*DOCUMENT NO:* OP-1903.034

*TITLE:* EMERGENCY OPERATIONS FACILITY  
EVACUATION

*REVISION NO:* 014-00-0

*CHANGE NO:* AP-14

ALTERNATE EOF WORK AREAS AND ROOM ASSIGNMENTS

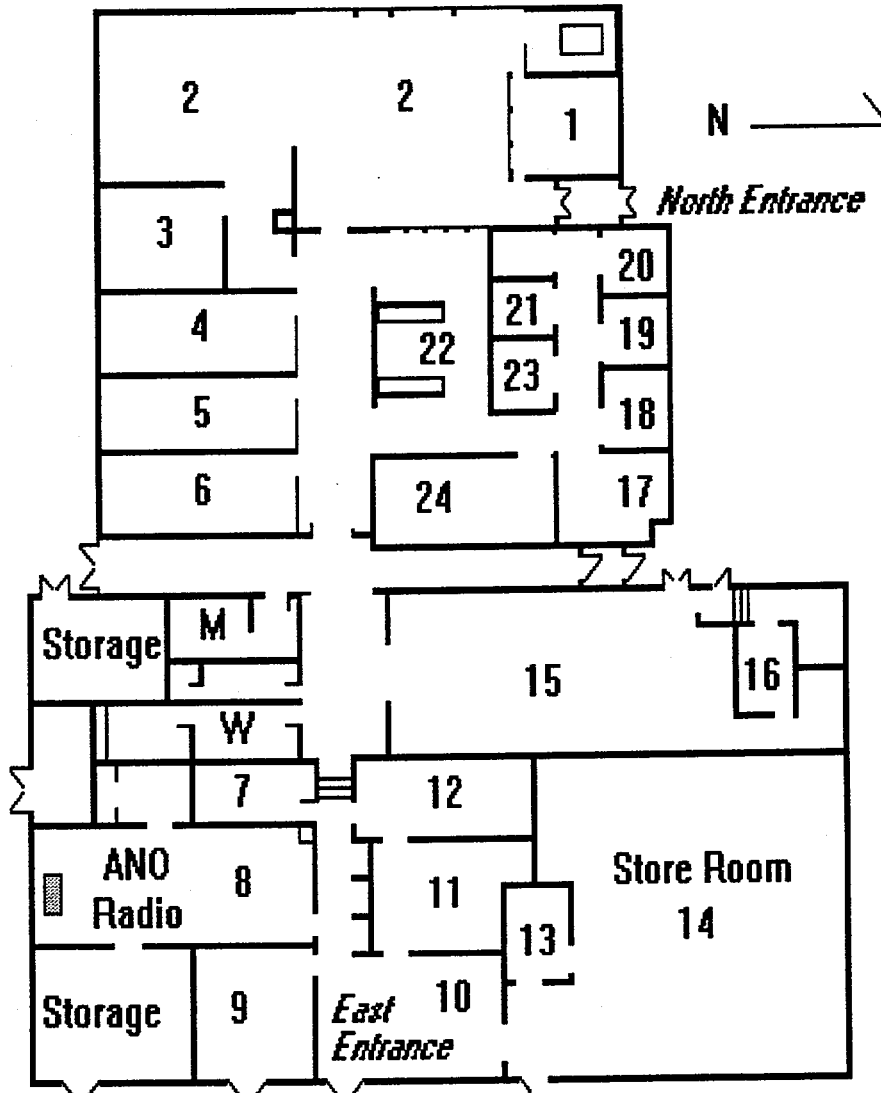
Attachment 4, 5

Removed REAM Assistant
